**ADDENDUM
NO. 1**

March 3, 2021

Scott County School District 1 – Austin Elementary Additions & Renovations and HS Pool Renovation
Austin, IN 47102

ADDENDUM NO. ONE

3 ENLARGED PLUMBING DEMOLITION PLAN
1/4" = 1'-0"

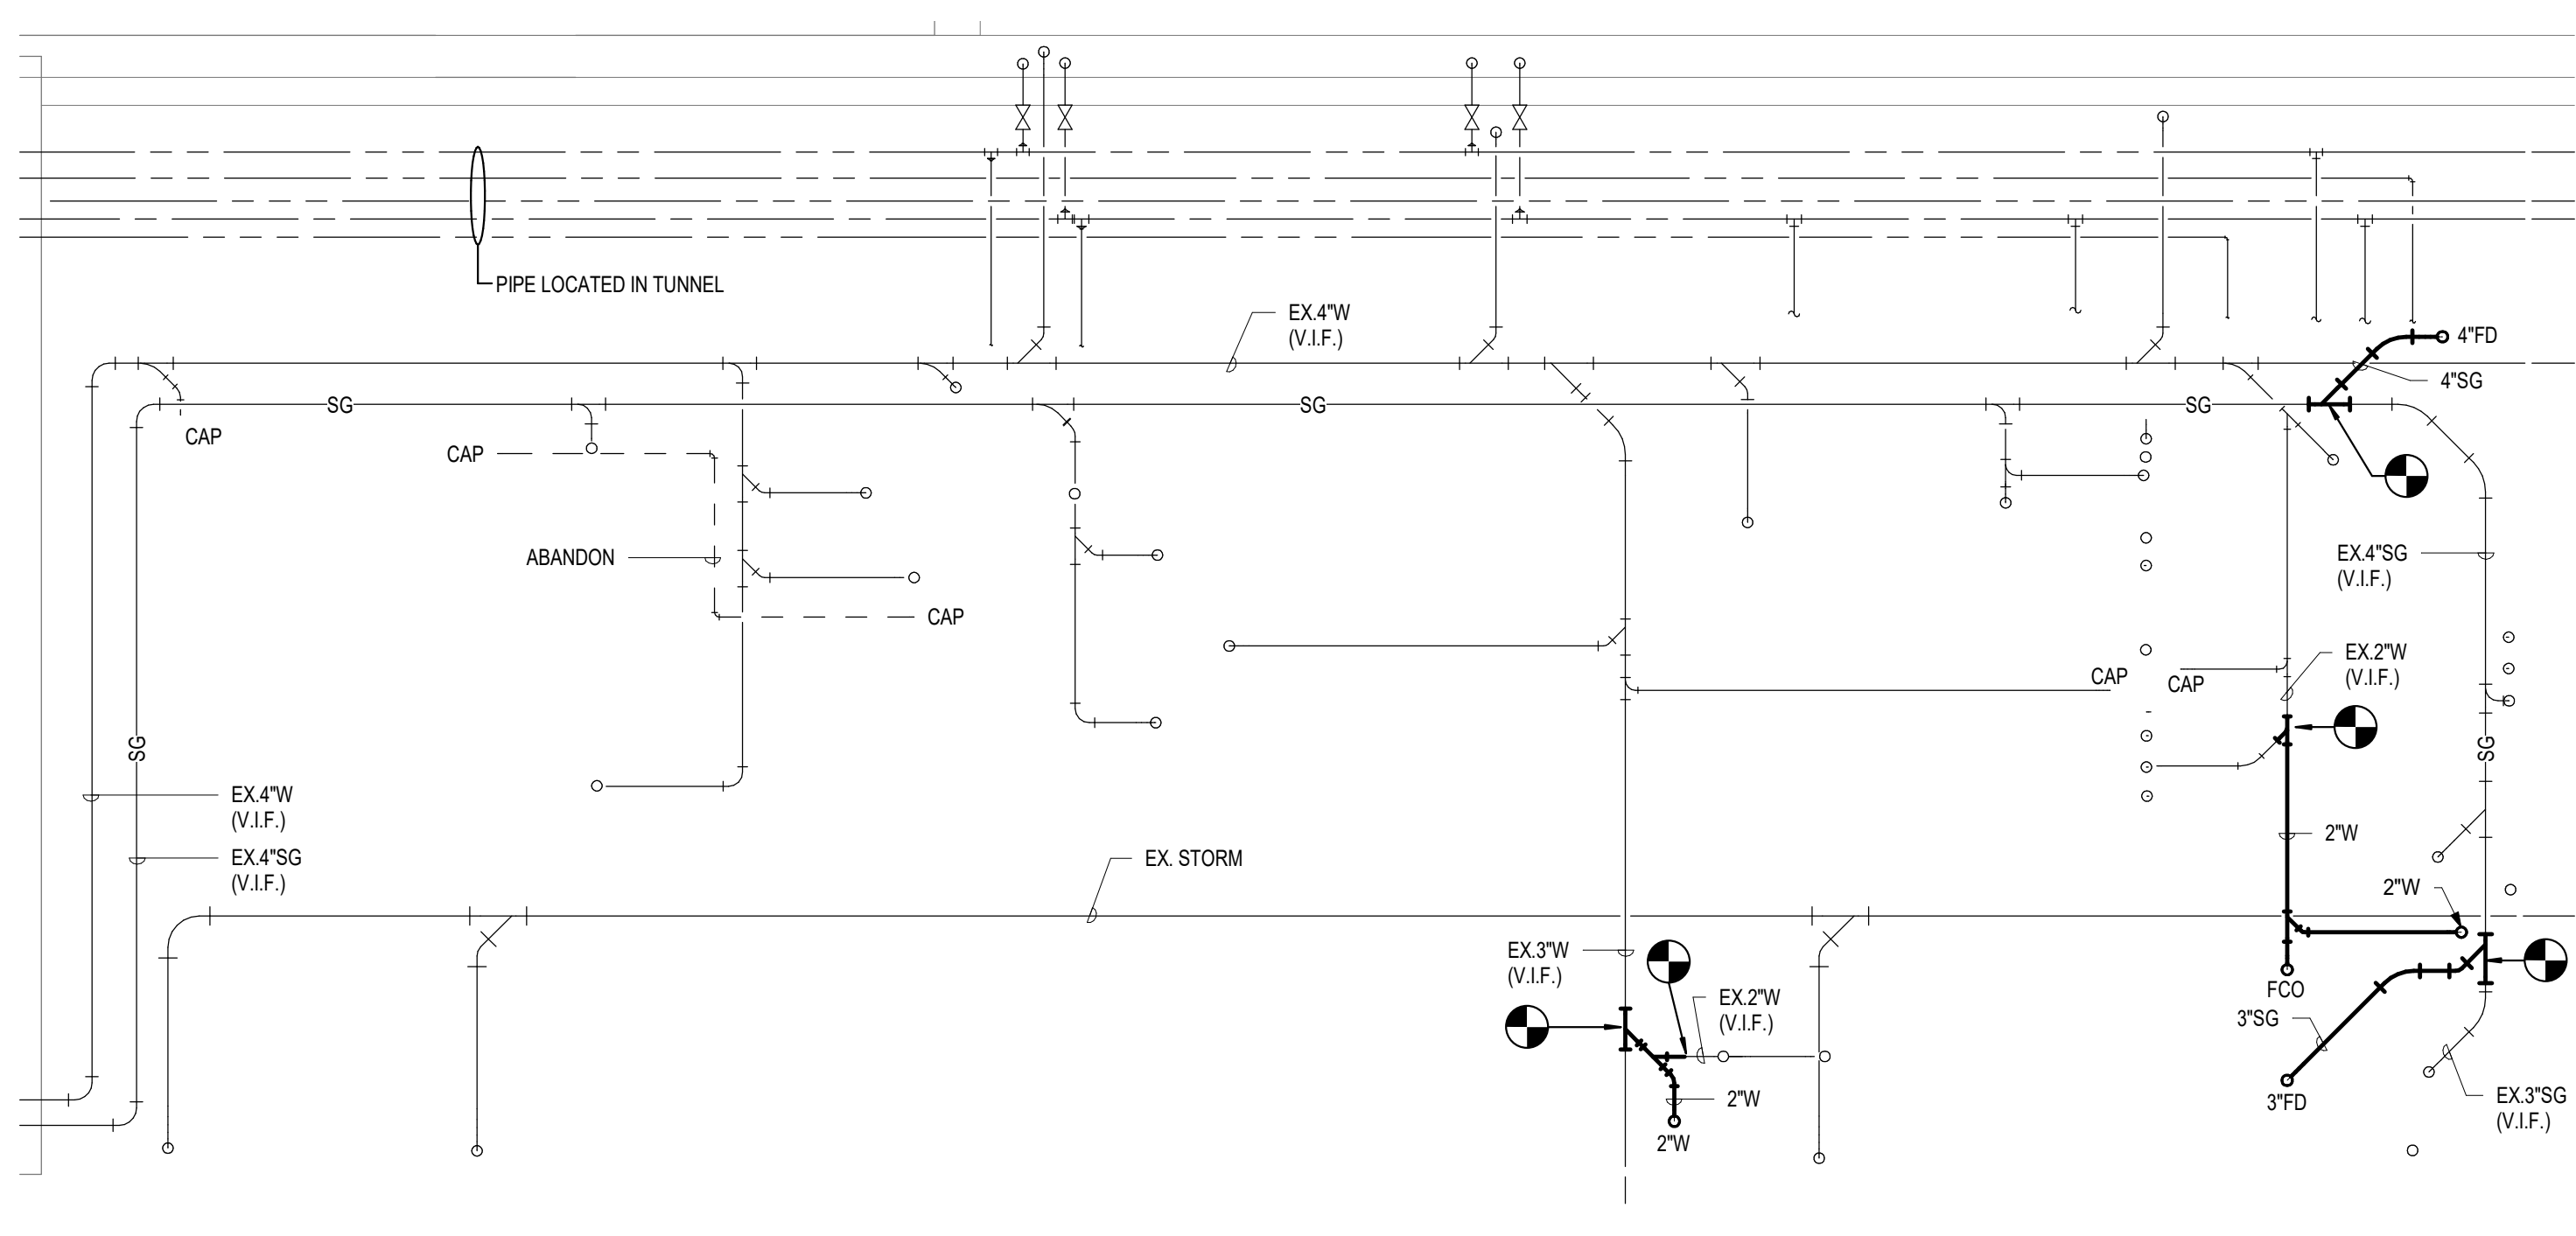
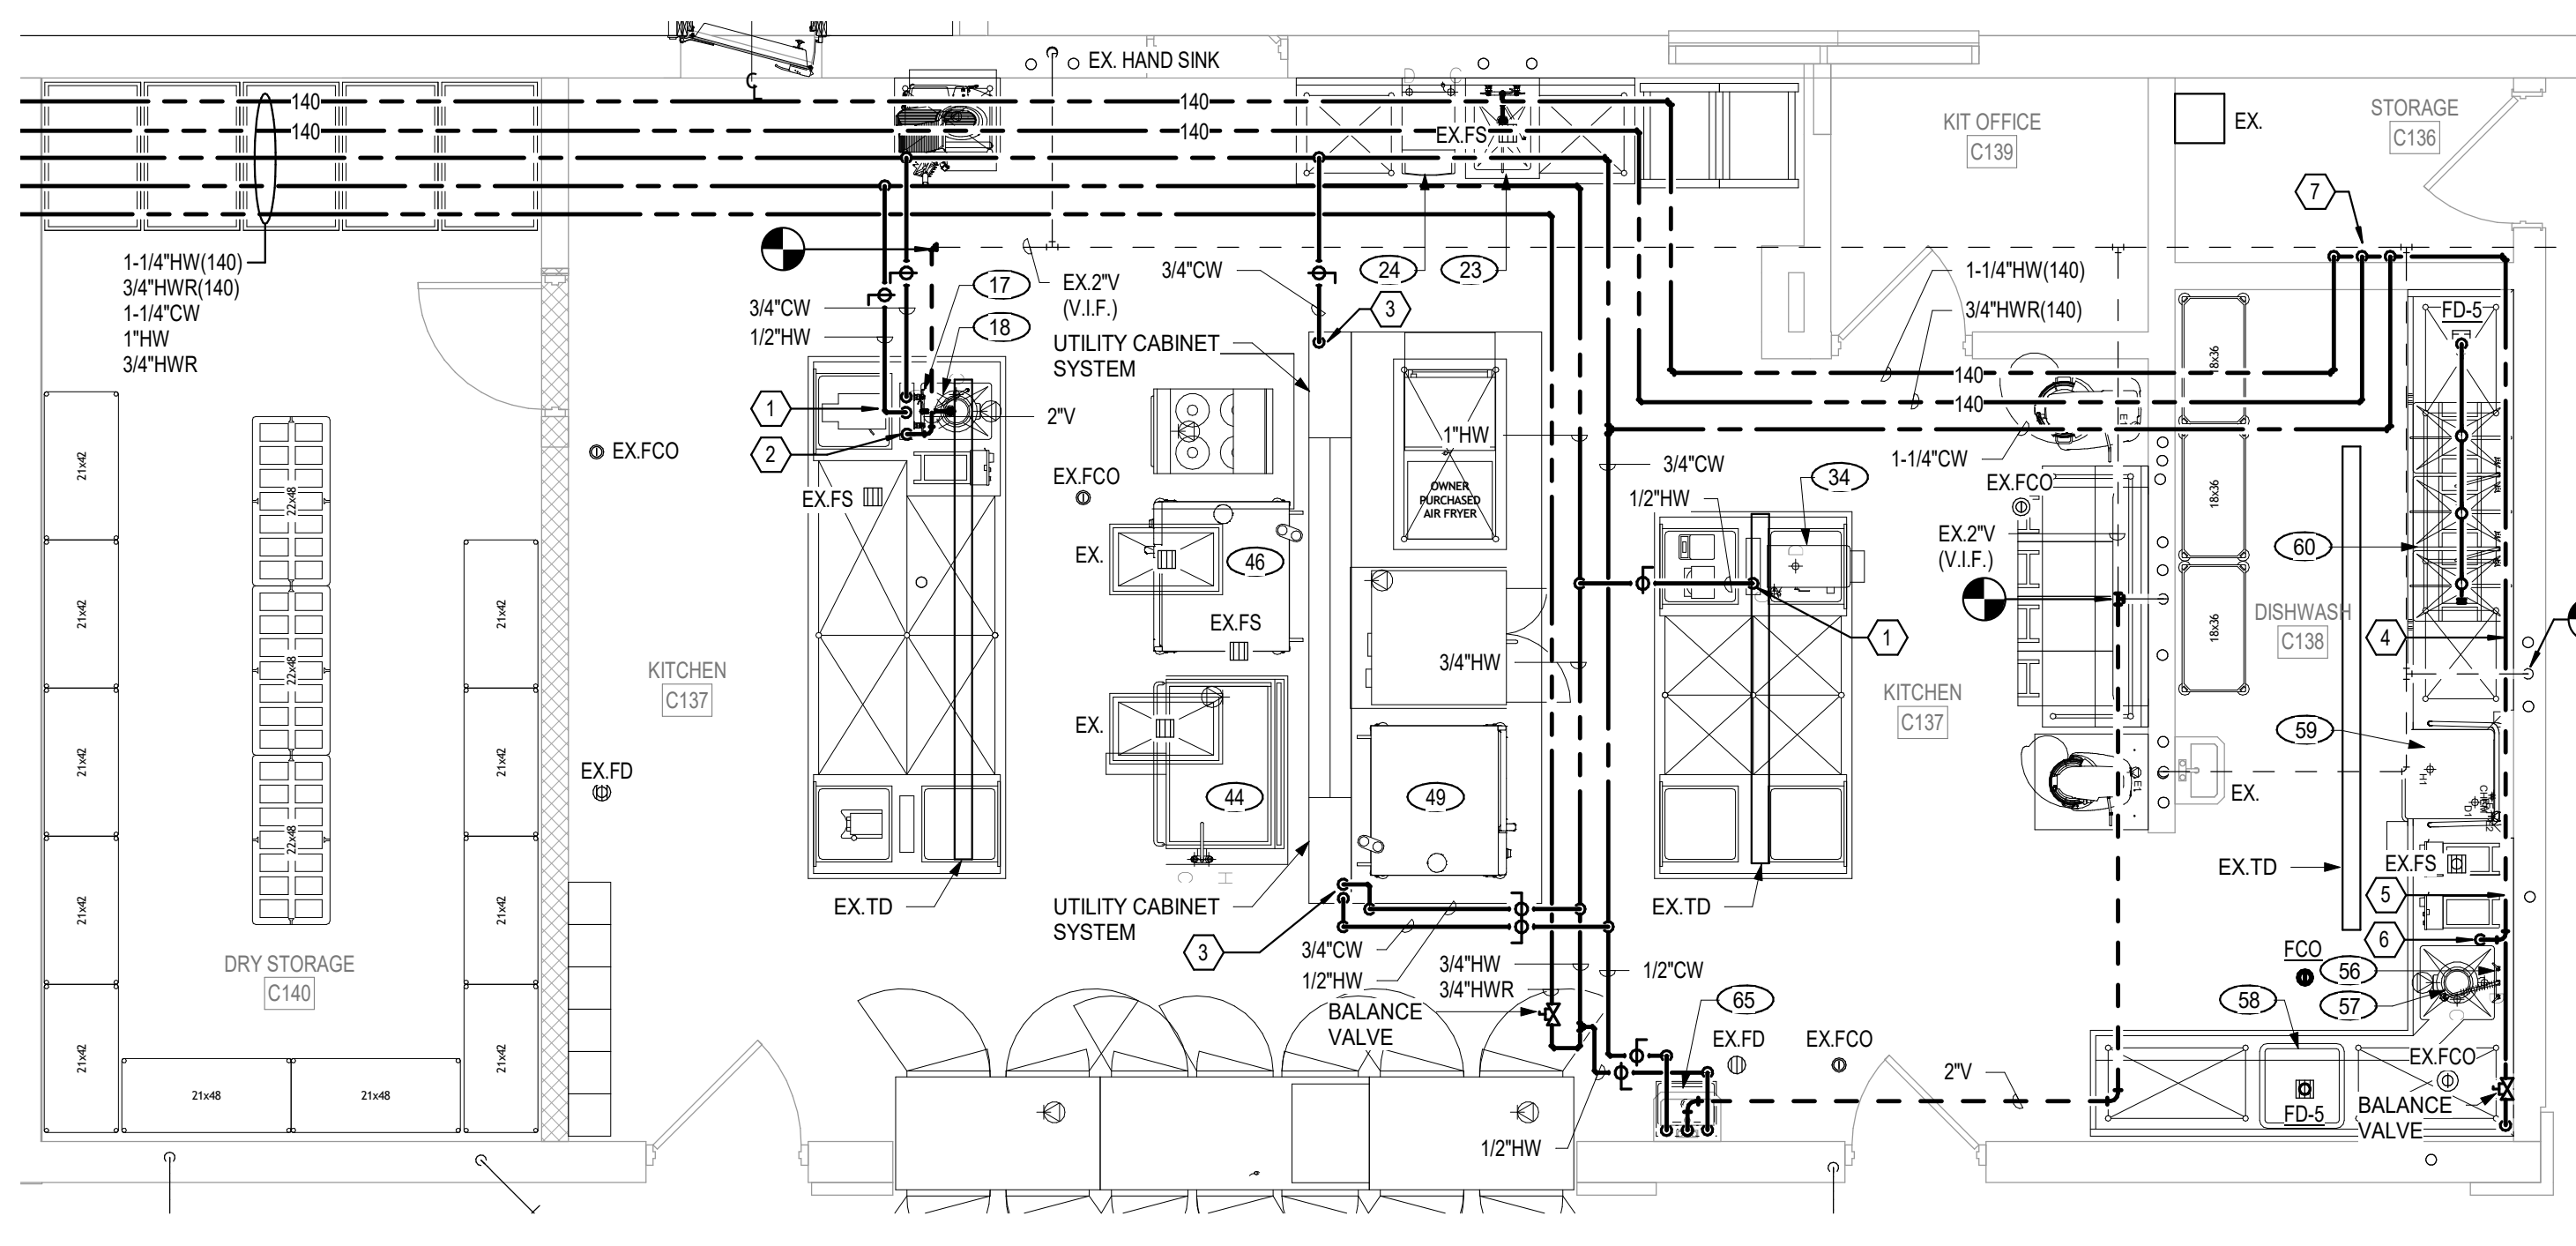
5. Drawing No.: P401
Drawing Sheet Title: ENLARGED PLUMBING PLANS
Revision: Add domestic cold water, domestic hot water, and domestic hot water return lines to serve the Kitchen. See attached drawing.

6. Drawing No.: P402
Drawing Sheet Title: ENLARGED PLUMBING PLANS
Revision: Add plumbing scope associated with the Kitchen area. See attached drawing.
7. Drawing No.: P601

EP101C

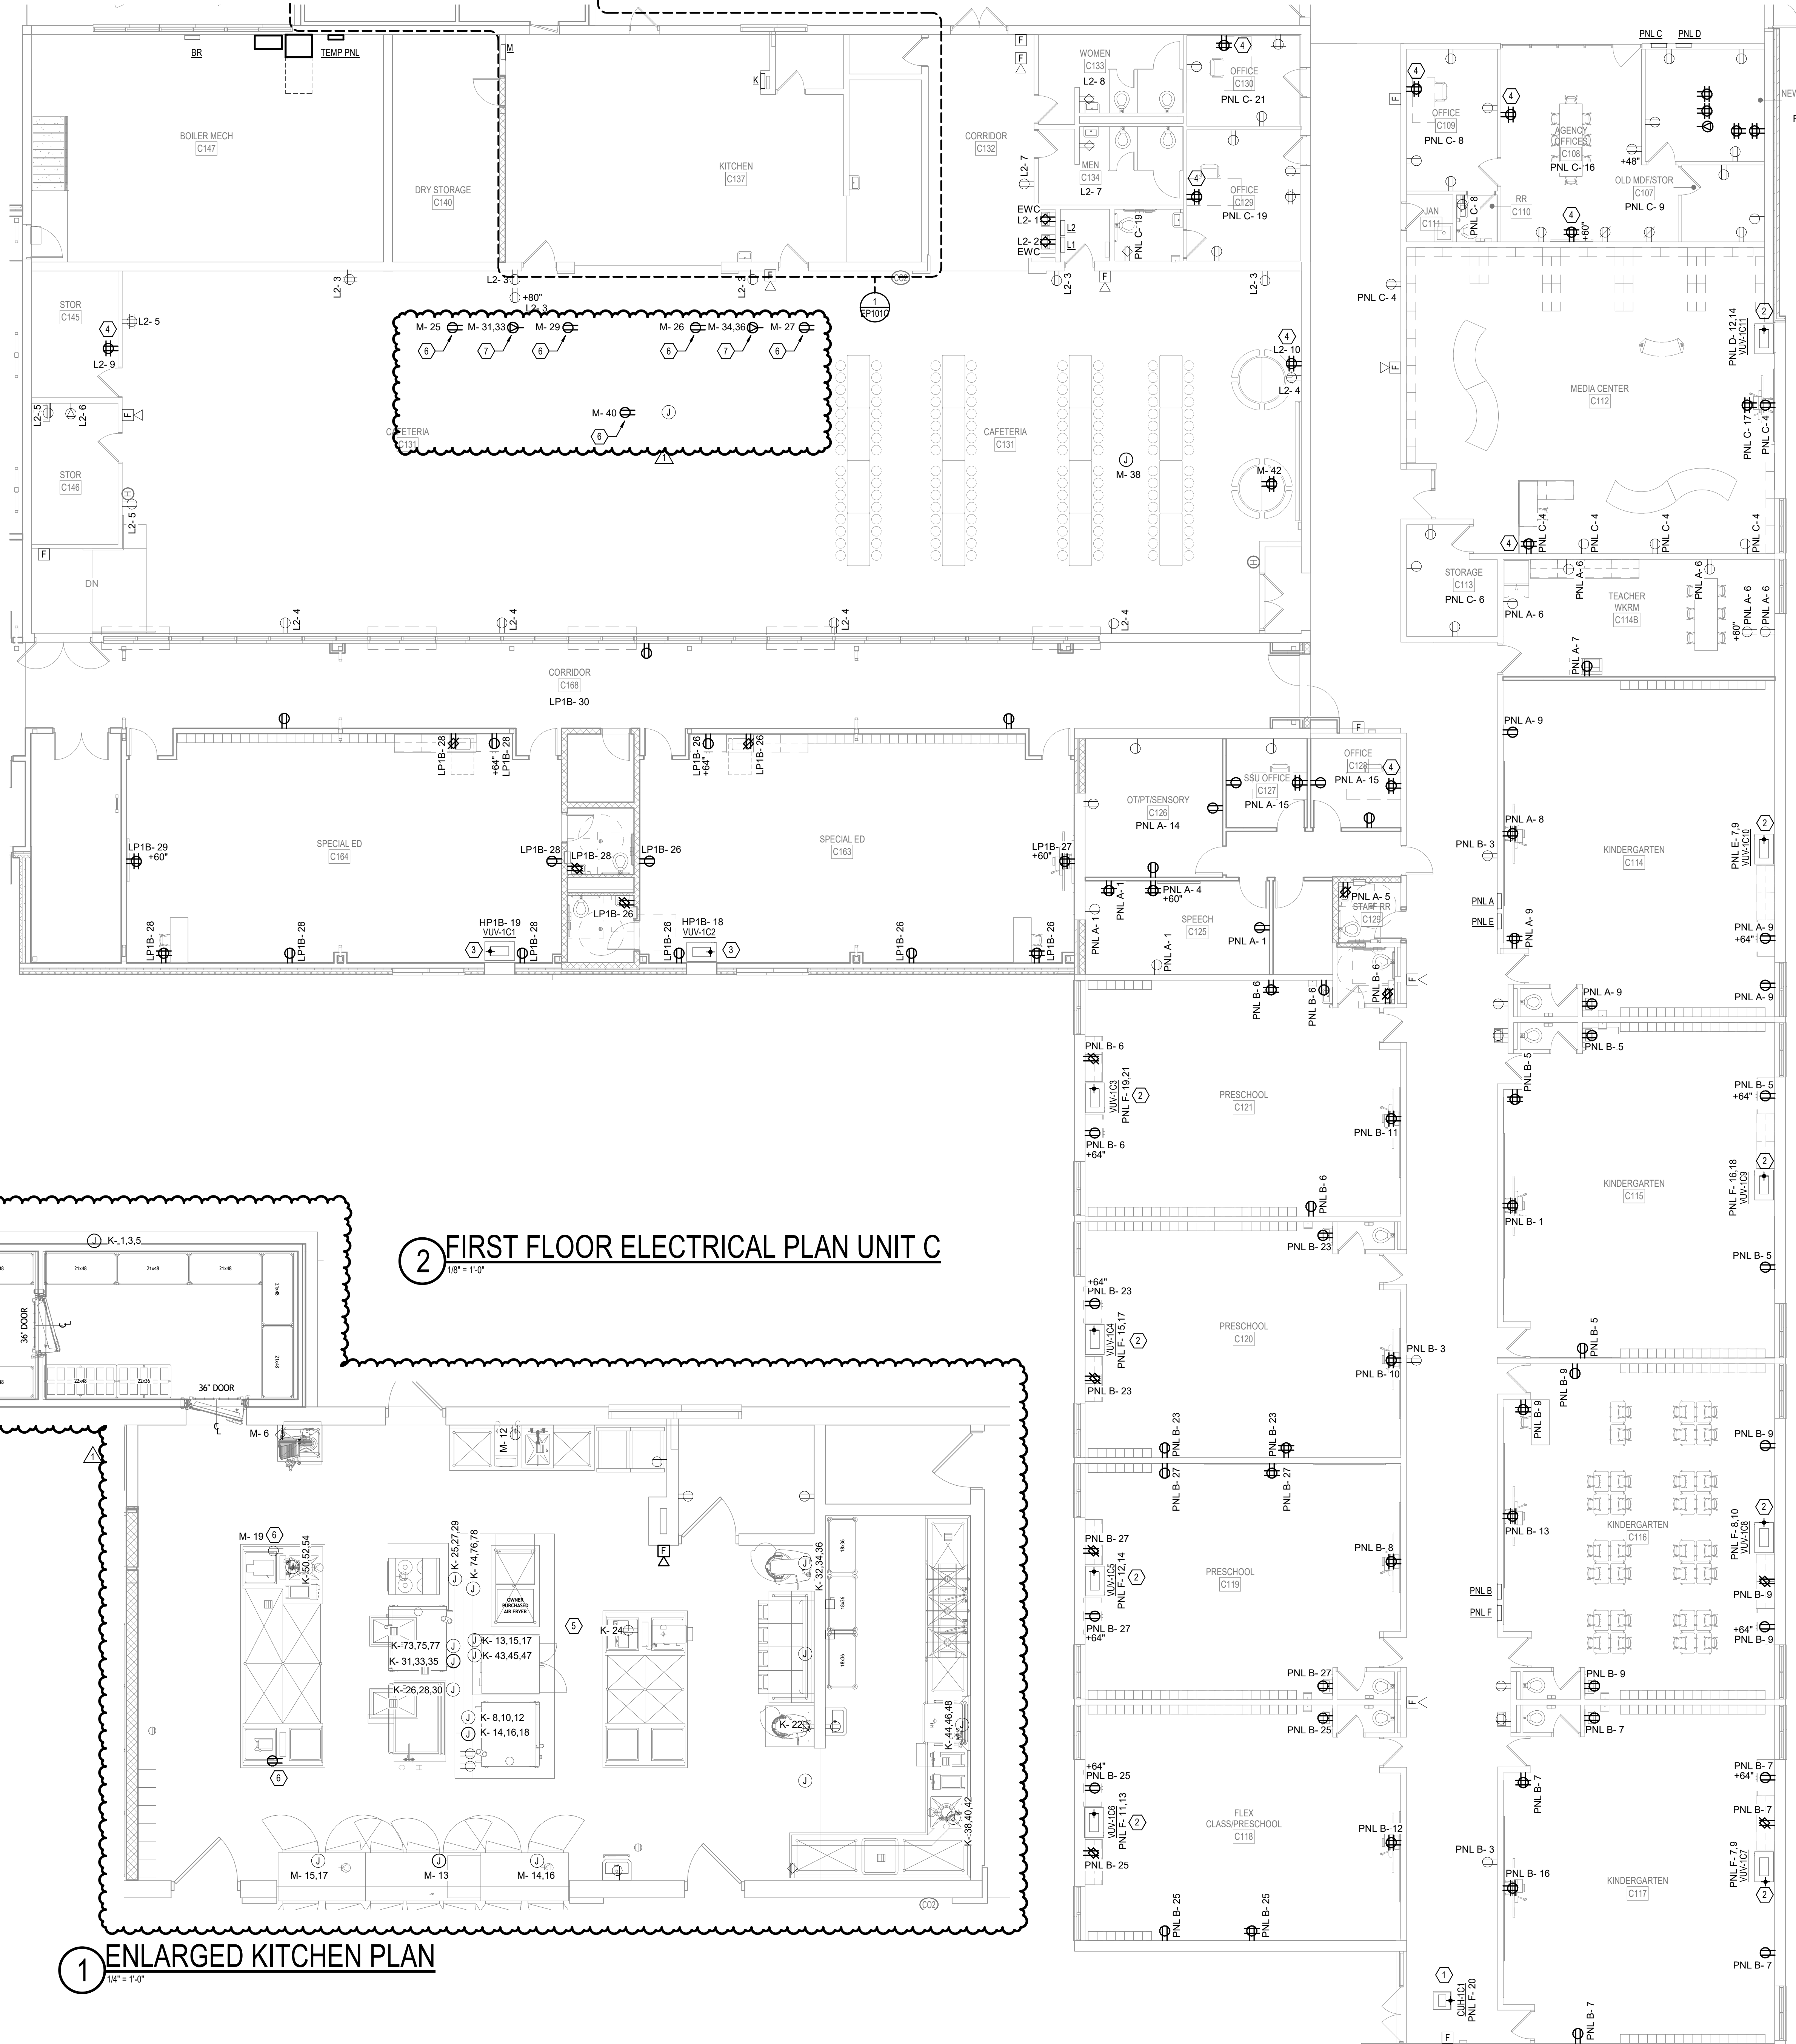
1. Drawing No.: EP101C
Drawing Sheet Title: FIRST FLOOR ELECTRICAL PLAN – UNIT C
Revision: Add details to better coordinate kitchen equipment.
2. Drawing No.: E602
Drawing Sheet Title: ELECTRICAL SCHEDULES
